Access Compliance Report

Public Rights-of-Way

(Curb Ramps)

Intersection ID: 15060	Main Street: DOROTHY_DR	Cross Street: IVERSON_WY	Location:	E
ADA ID: 10601EBD931E	Ramp Type: Directional1	Initial Pass/Fail: Fail	Overall Compliance: No	Severity Score: 1.25
Codes/Mitigation Info/Possible Solution		Field Measurements/Component Compliance

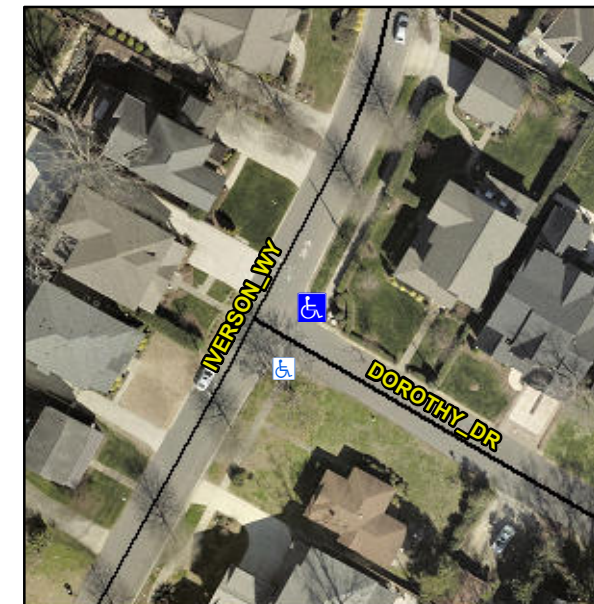
Compliance	Description	Data	Compliance	Description	Data
N/A	Ramp Length (in)	135.0	N/A	Grade Break?	N/A
Yes	Ramp Width (in)	58.0	N/A	Grade Break Slope (%)	0.0
Yes	Ramp Slope (%)	6.7	N/A	Grade Break XSlope (%)	0.0
No	Ramp XSlope (%)	3.4			
N/A	Flare Type LT	N/A	N/A	Flare Type RT	N/A
N/A	Flare Slope LT (%)	N/A	N/A	Flare Slope RT (%)	0.0
N/A	Flare Traversable LT?	N/A	N/A	Flare Traversable RT?	N/A
N/A	Landing Length (in)	0.0	N/A	DWS Provided?	N/A
N/A	Landing Width (in)	0.0	N/A	DWS Contrast?	N/A
N/A	Landing Slope (%)	0.0	N/A	DWS Length (in)	N/A
N/A	Landing X Slope (%)	0.0	N/A	DWS Full Width?	N/A
N/A	Landing Curb? (Y/N)	N/A	N/A	DWS Offset LT (in)	N/A
N/A	Shared Landing?	N/A	N/A	DWS Offset RT (in)	N/A
N/A	Gutter Ponding?	0.0	N/A	Gutter Slope (%)	N/A
N/A	Gutter Lip Ht (in)	0.0	N/A	Gutter X Slope (%)	N/A
N/A	Painted X Walk1?	No		Road Slope (%)	1.7
	X Walk 1 Direction	To S		Road X Slope (%)	0.9
	X Walk 1 Width (in)	N/A		Clear Space?	N/A

X Walk 1 Slope (%)	1.7	N/A	Clear Space to XWalk (in)	N/A
	X Walk 1 X Slope (%)	0.9	N/A	Storm Grate/Utility Hazard?	N/A
N/A	Ramp inside XWalk1?	N/A		Storm Grate/Utility Type	
N/A	Any Obstructions?	N/A			N/A
	Obstruction Type		Yes	Surface Condition? (G/P)	Good
			N/A	Curb Slope (%)	8.7

Remove & Replace Entire Ramp.
